FOR: The Commissioners
FROM: William Travers
Executive Director for Operations
SUBJECT: LICENSING APPROACH FOR EXELON'S PEBBLE BED MODULAR REACTOR

Staff Preliminary Assessment of Exelon's Proposed Licensing Approach

Figure 1

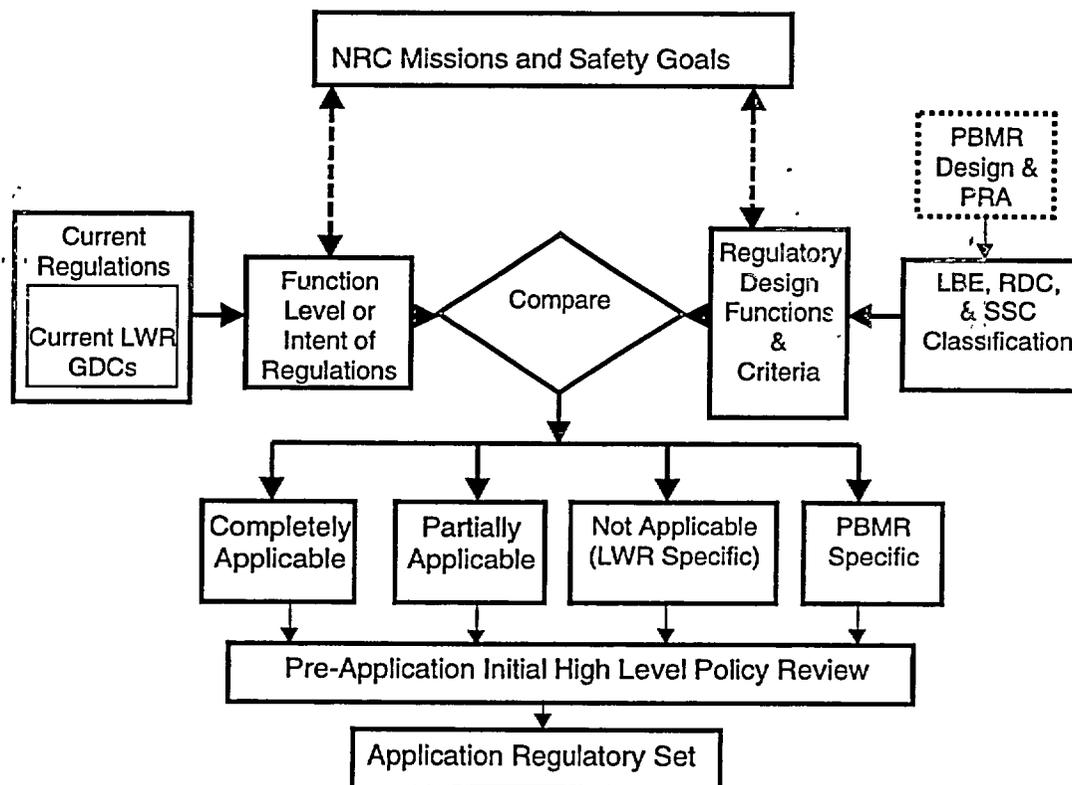
The staff recognizes that this process only addresses the regulatory issues that have been identified as part of the development of LWR regulations. This is why the information represented by the boxes on the top right of Figure 1 concerning regulatory design functions and criteria is needed to fully elicit and identify PBMR-specific issues.

In the absence of design details that are required for a final PRA, the applicant must make assumptions regarding the design and performance of various systems (in consideration of the right-hand side of Figure 1); these assumptions need to be explicitly identified so as to make the applicant accountable for validating them.

Figure 2

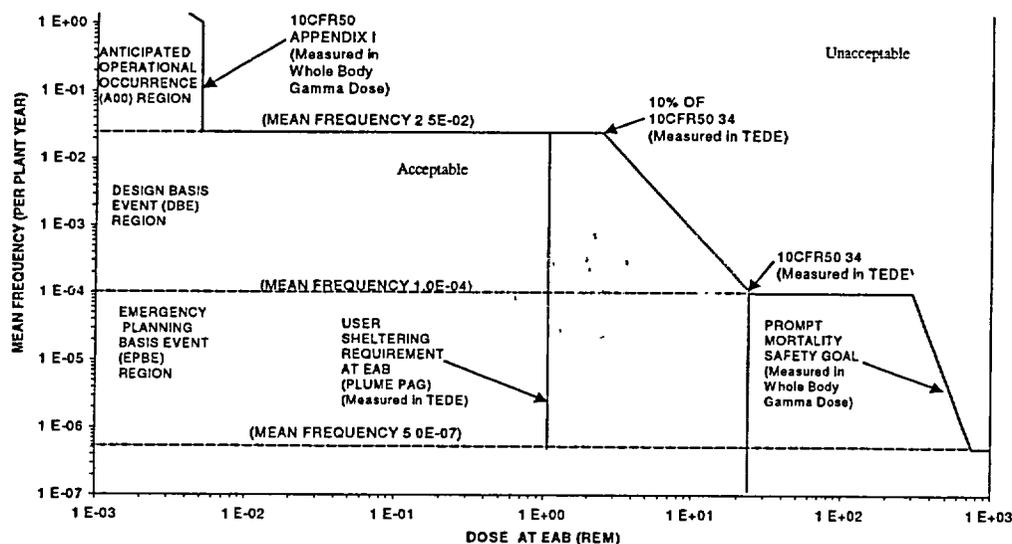
Exelon's proposed licensing approach, as it relates to applicability of NRC regulations, focuses on the safety regulations contained in the current 10 CFR Part 50. Exelon's plotting of the TLRC is consistent with past principles, but poses technical challenges, such as determining the appropriate frequency ranges applicable to each of the regions. The current regulations include a frequency reference for the definition of AOOs, but do not contain a similar reference for DBEs. Exelon has chosen 1×10^{-4} per plant year as the lower frequency for a DBE. The staff will continue to assess the appropriateness of this value and its consistency with current practice and the criteria contained in SECY-00-198 which discusses RIP 50 Option 3, taking into account such considerations as cumulative effects (for the families of events and for multiple modules) and the frequency ranges considered in other advanced reactor reviews. In the event that such technical questions arise, they might have concomitant policy implications which could require Commission guidance before such questions can be resolved. Some of these technical and policy issues have been identified in this assessment, but more could arise as the staff's pre-application review proceeds. For example, the TLRC use one of the quantitative health objectives (QHO) from the Commission's safety goal policy (i.e., the risk of prompt fatality); however, the other QHO on latent cancer risk is not addressed. On the other hand, staff expects continued interactions with Exelon to help clarify some issues.

The staff notes that plotting of TLRC is useful to illustrate bounding criteria and safety margins. However, the licensing basis is the set of requirements that are applied to the safety-related equipment to meet the licensing basis events (or other special regulatory objectives such as anticipated transients without scram (ATWS) or station black-out (SBO)); simply falling within the plot of the TLRC does not in itself constitute an acceptable licensing basis. Moreover, while the PRA confirms risk insights for a design, and can be used for other purposes as noted above, licensing is still carried out on a "deterministic" basis.

Figure 3: Radionuclide Retention Functions for the MHTGR

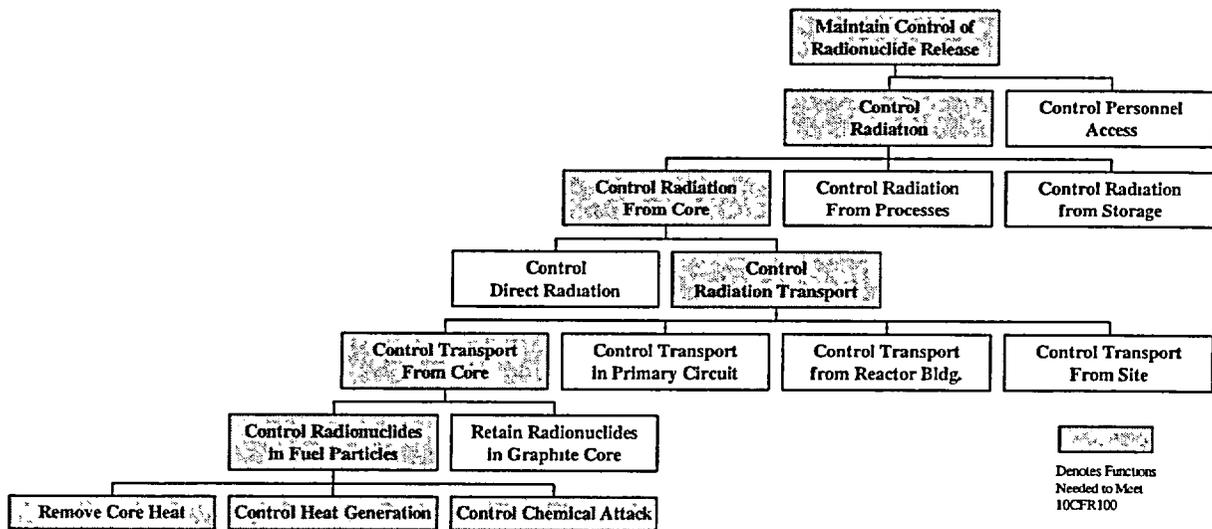
While the staff understands that this is not a PBMR-specific figure, the figure seems to imply that the function can be met without controlling radionuclide transport from the reactor building and from the site, which appears to contradict the defense-in-depth philosophy. The role of a containment in the PBMR design will be specifically addressed and is expected to be presented to the Commission as a policy issue. The staff believes that system redundancy, defense-in-depth, and maintenance of safety margins should be incorporated into the process for categorizing SSCs as safety-related. The staff will continue to discuss these concerns with Exelon in its pre-application review.
